MILITARY SPECIFICATION

SEMICONDUCTOR DEVICE, SILICON,
VOLTAGE REFERENCE (TEMPERATURE-STABLE)
TYPE 1N430A, 1N430B

This amendment forms a part of Military Specification MIL-S-19500/335(EL) 1/, 28 June 1965, and is approved by the US Army Electronics Research and Development Command, Department of the Army, and is available for use by all Departments and Agencies of the Department of Defense.

MIL-S-19500/335(ER)
AMENDMENT 2

FIGURE 1. Physical dimensions.

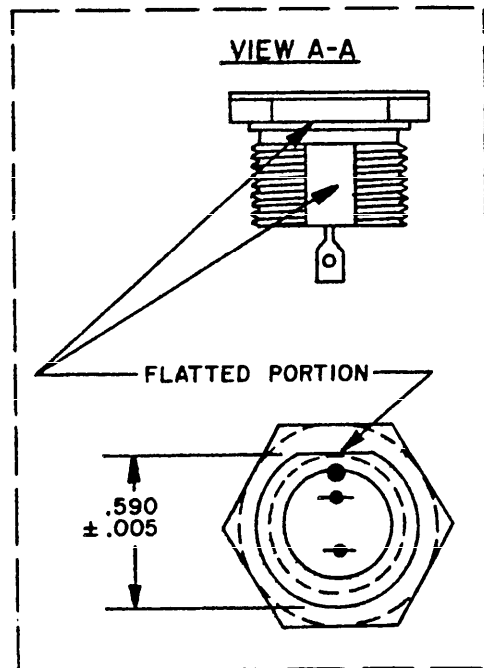
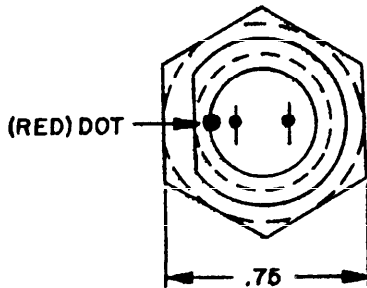
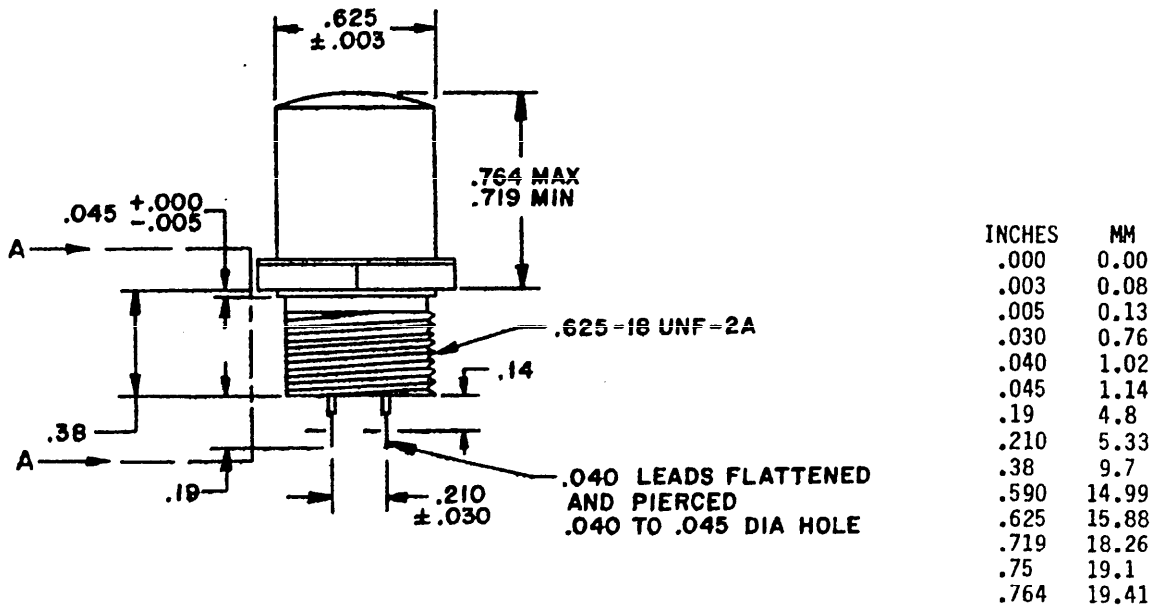
Figure 1, delete and substitute new figure 1 as printed on page 2 of this amendment.
